OBJECTION TO STATE SIGNIFICANT DEVELOPMENT APPLICATION
SSD-93020230
RESIDENTIAL FLAT BUILDING WITH IN-FILL AFFORDABLE HOUSING

A. Introduction

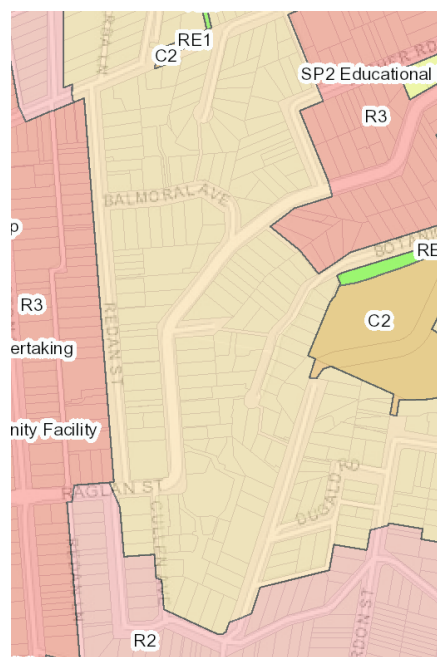
14. The section of Redan Street, between Almora Street and Raglan Street to which the heritage listing refers, can be seen in the image from Google Maps below:
